**AGENDA**  
**Canmore Planning Commission**  
**Canmore Civic Centre – Council Chambers**  
**Wednesday, March 20, 2024**  
**2:00 p.m.**

## STAFF REPORT

<b>DATE:</b>	MARCH 20, 2024
<b>PROPOSED DEVELOPMENT:</b>	COMPREHENSIVELY DESIGNED MULTI-UNIT RESIDENTIAL DEVELOPMENT (18-UNIT STACKED TOWNHOUSE)
<b>APPLICATION NUMBER:</b>	PL20230389
<b>LEGAL DESCRIPTION:</b>	LOT 29, BLOCK 21, PLAN 231 690
<b>CIVIC ADDRESS:</b>	205 STEWART CREEK RISE
<b>CURRENT USE(S):</b>	VACANT LAND
<b>APPLICANT:</b>	CANMORE COMMUNITY HOUSING
<b>REFERENCED DOCUMENTS:</b>	LAND USE BYLAW 2018-22: <ul style="list-style-type: none"><li>• SECTION 3.21 R2A-SC DISTRICT</li><li>• SECTION 11 COMMUNITY ARCHITECTURAL &amp; URBAN DESIGN STANDARDS</li><li>• SECTION 12. DENSITY BONUS REGULATIONS</li></ul>

Figure 1 – North Elevation of the North Building and Site Plan

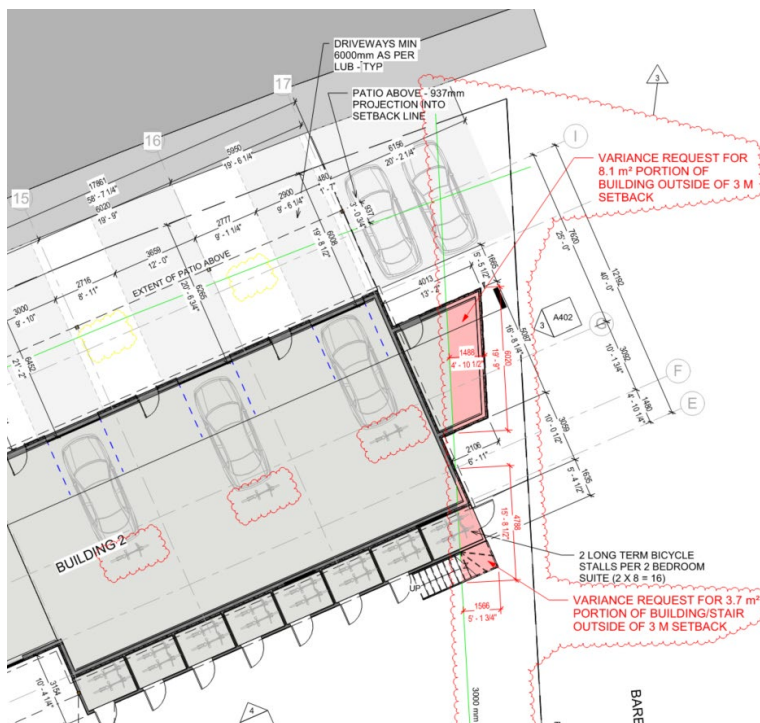
The proposed north building is 1.6 m from the east property line, resulting in a 1.4 m variance to the above standard. The size of the variance (46.7%) is allowable as per Section 1.14.3, which allows for the variance powers of the development authority, identified under Section 1.14, to be increased where the proposed development provides an extraordinary net benefit to the community. Given the proposed development is for Vital Homes, Administration believes this criterion is met.

With regards to impacts on adjacent development to the east, the development does not appear to unreasonably impact the access to views, privacy, or light. The subject development runs east-west, so it will not shade the adjacent development. The proposed use of this portion of the building is for a one-storey mechanical room, so privacy will not be of concern (see Figure 1). With regards to views, the R2A-SC District allows for non-comprehensively designed multi-unit residential developments, for example, a single row of townhouses to be up to 1.5 m from the side property line. This would have the same, if not more impact on the adjacent development than that proposed. Given the community benefit and minimal impacts on adjacent properties, Administration supports the proposed variance.

Related to this variance are three projection variances - the eaves above the east side of the north building, the rear common deck behind the north building (above the bicycle storage rooms) and the stairway leading from the

deck to grade. Administration supports these variances for the same reasons as outlined above.

ELEVATIONS

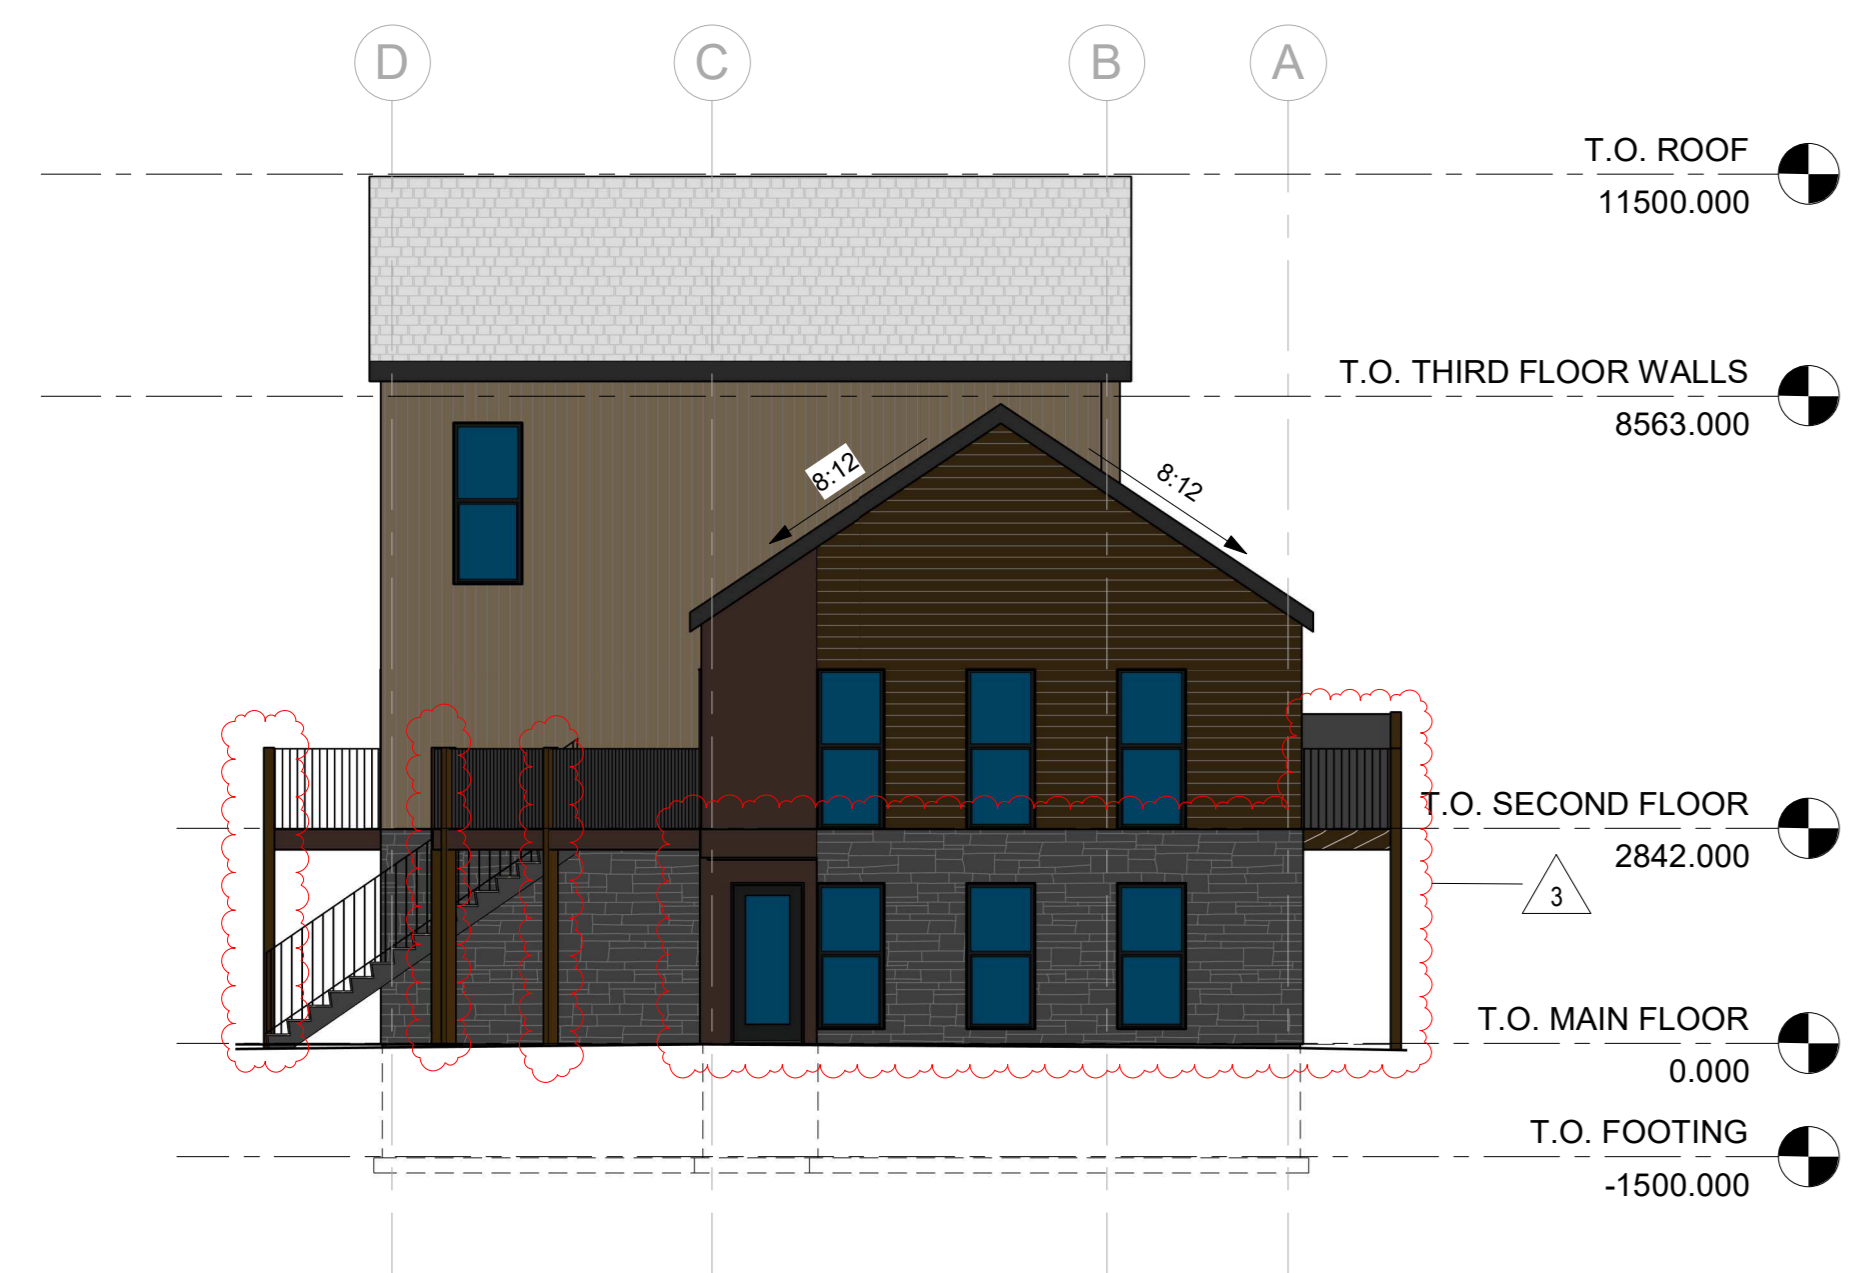
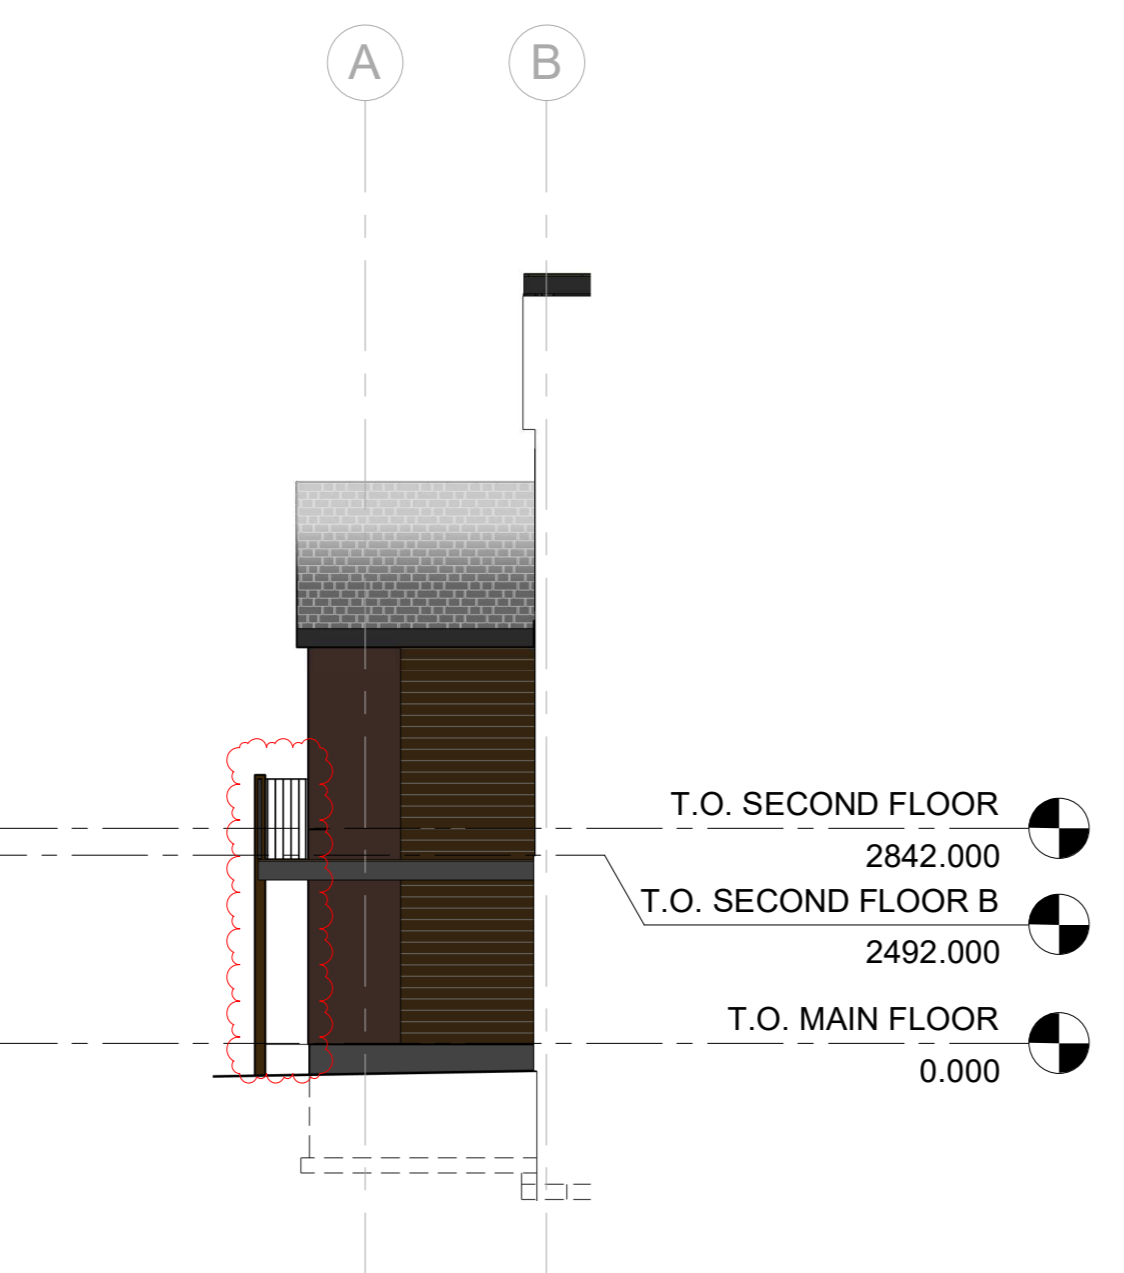
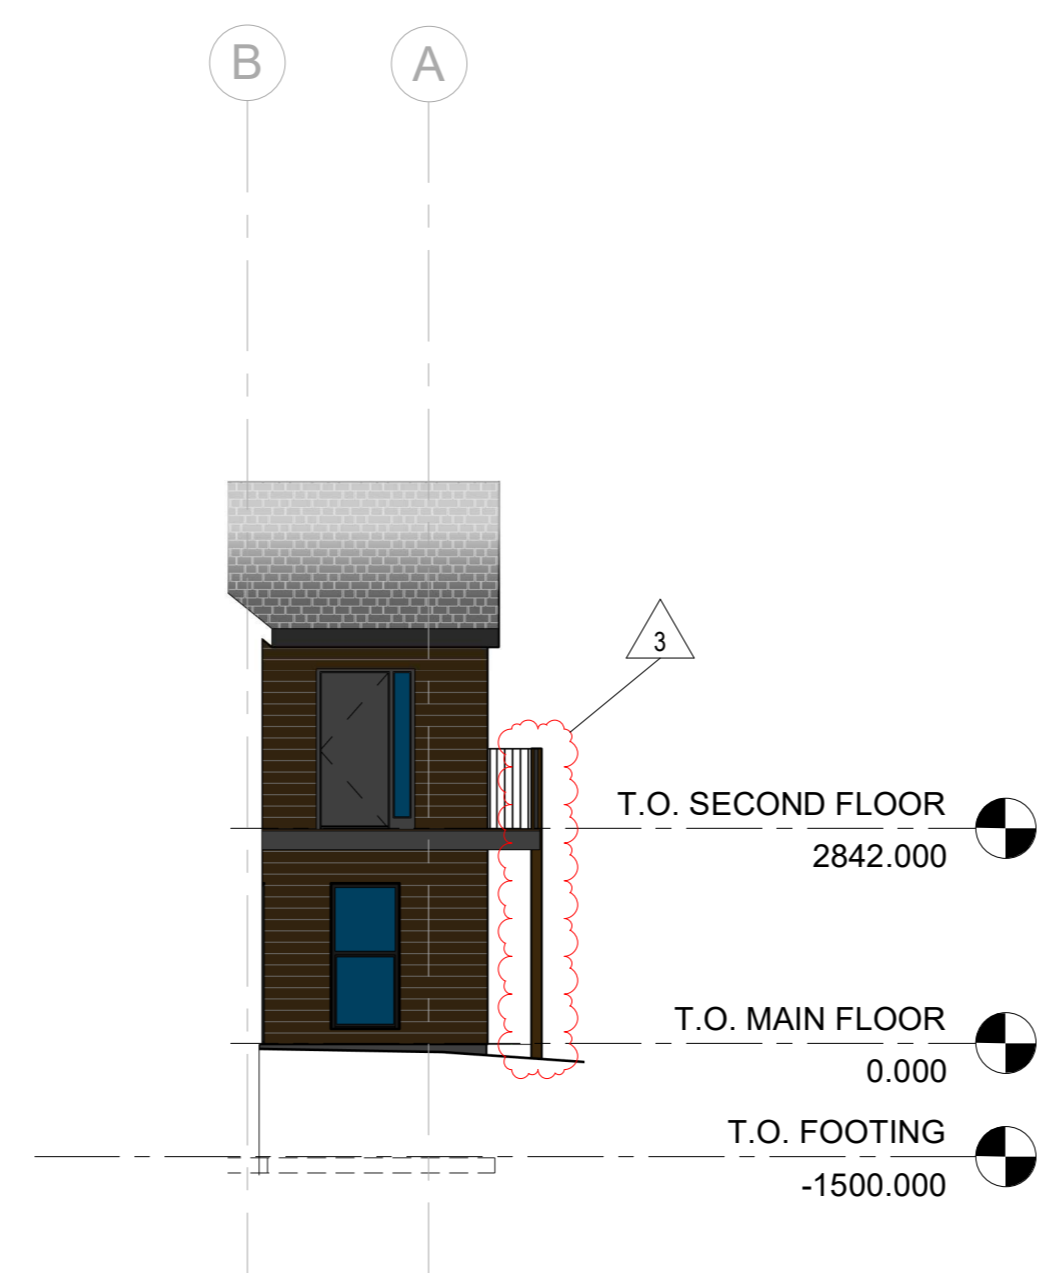
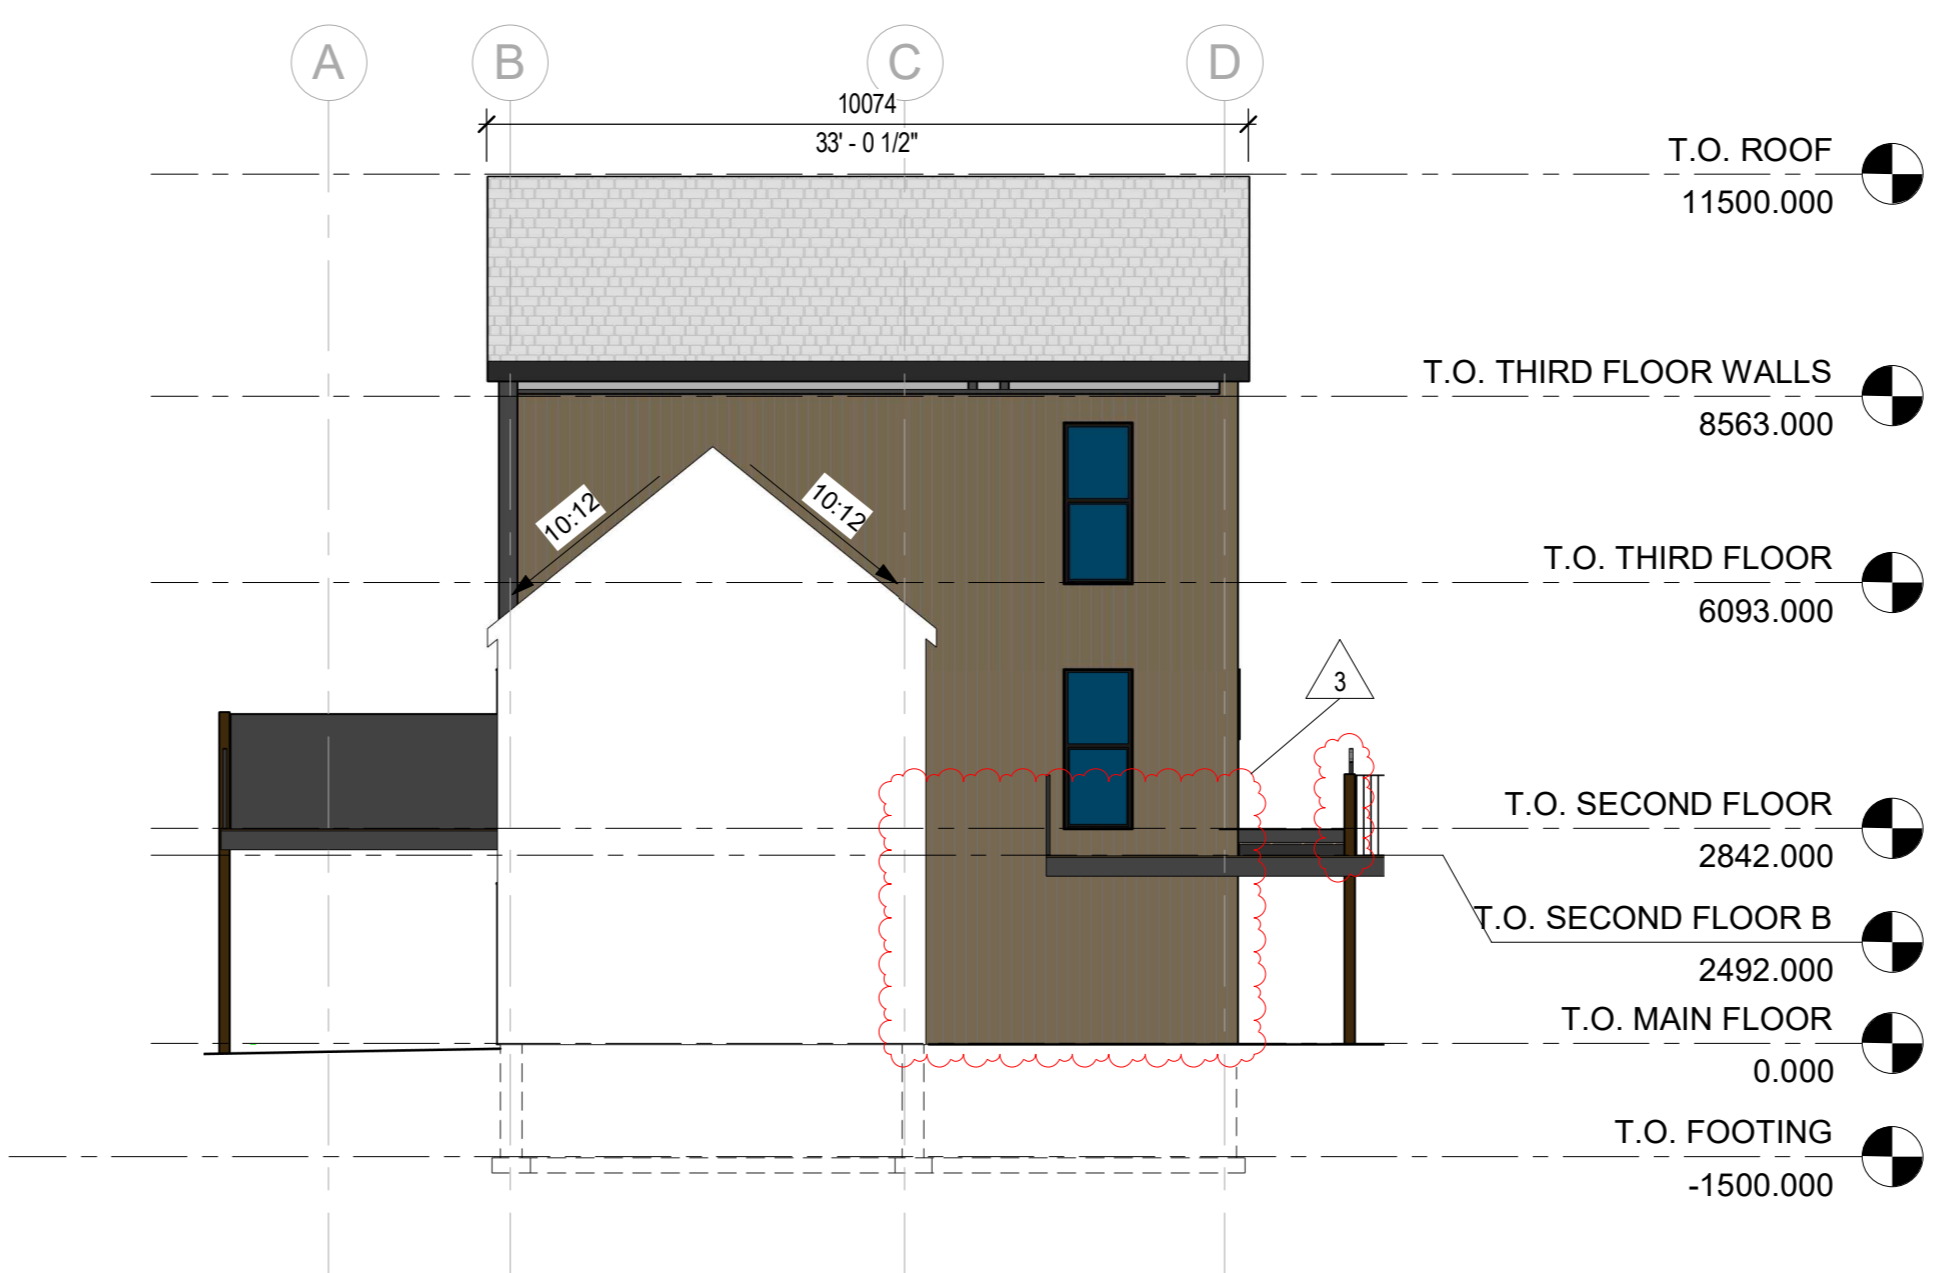
The proposed development is 11.67 m in height, requiring a 11.2% variance (see Figure 2 and 3).

With regards to impacts on adjacent developments, the development does not appear to unreasonably impact the access to views, privacy, or light of the adjacent properties. For example, the buildings step up as they move from their sides to their middle, which makes its impact on the east and west developments the same as, or even less than, a compliant building built to maximum height right to the setback (see Figures 2 and 3). Furthermore, there is 15 m of distance between the property line of this site and the adjacent site to the north. In addition, there is 26 m of separation between the rear property line of this site and the façade of the townhomes (excluding the garages) to the south. Finally, there are roof areas for both buildings that are substantially under height, which is to the advantage of the adjacent properties to the north and south.

Administration supports this variance given the community benefit of the project, and that the impacts of the variance are anticipated to be minor.
